Errata Report

**mP6TM MICROPROCESSOR
FOR WINDOWSTM SYSTEMS**

Preliminary

3. STOPCLK before INIT causes hang

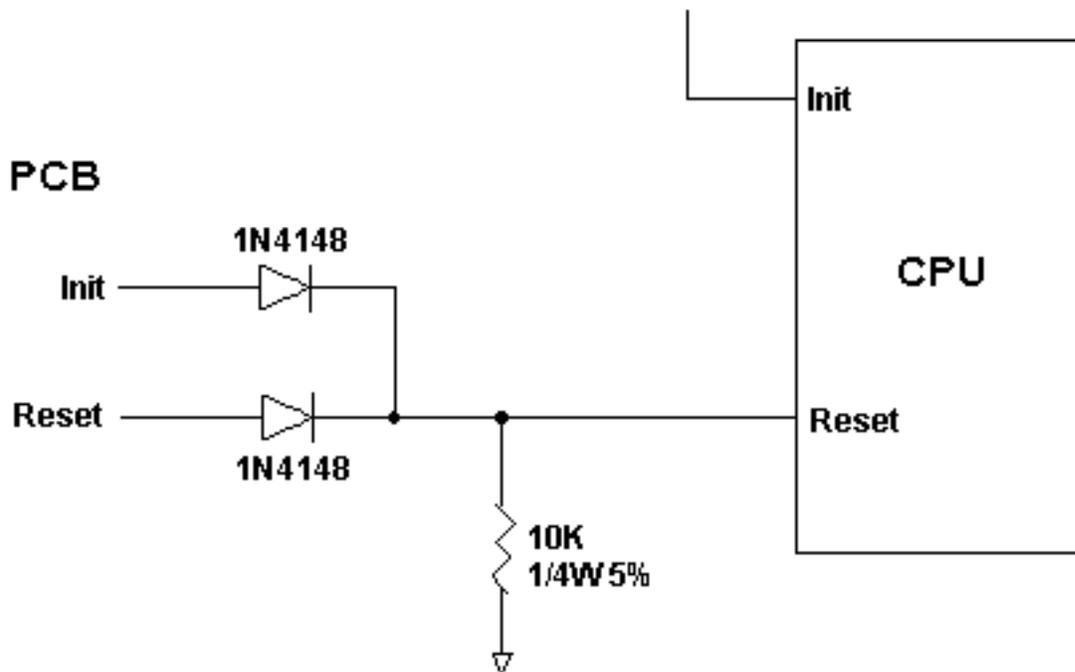
PROBLEM: System fails to boot with Rise™ mP6™ processor when STOPCLK is active during or shortly after RESET drops.

IMPLICATION: This problem has been observed only on the SMSC socket 7 motherboard with SLC90E42 Northbridge and SLC90E46 Southbridge at 2X mode; it has never been seen on a Super Socket 7 chipset.

WORKAROUND: Use a 2.5X ratio, or Run BIST at power on (refer to the modification below).

STATUS: There currently are no plans to fix this erratum. Expecting SMSC to change future chipset revision such that STOPCLK is not active during RESET.
